SUNDRY NOTICES AND REPORTS ON WELLS

7. Farm or Lease Name: GILBERT DITCH UNIT

8. Well No.: 34-73 4-2H

Please see the revised footages:

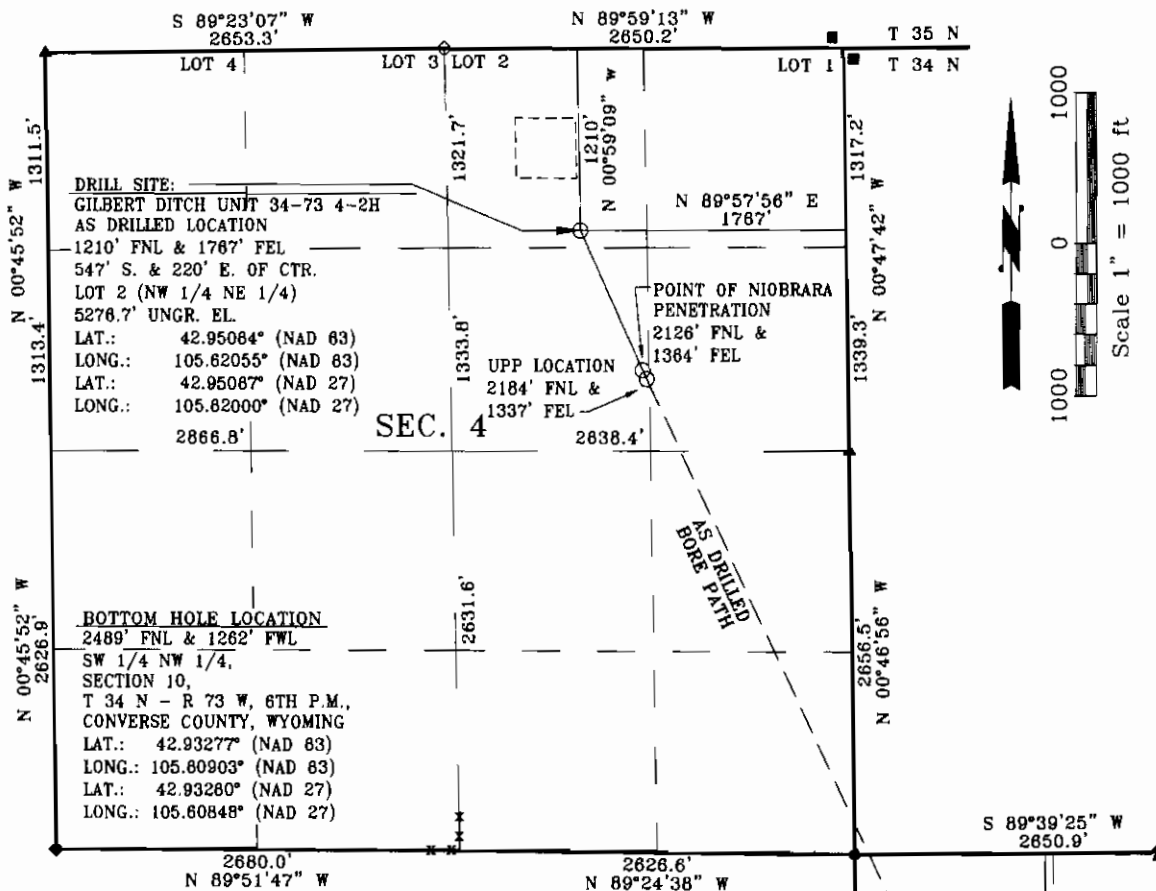
SHL: 1210 FNL & 1767' FEL Lot 2 NWNE Section 4-34N-73W
 42.95084; -105.62055

BHL: 2489' FNL & 1262' FWL SWNW Section 10-34N-73W
 42.93277; -105.60903
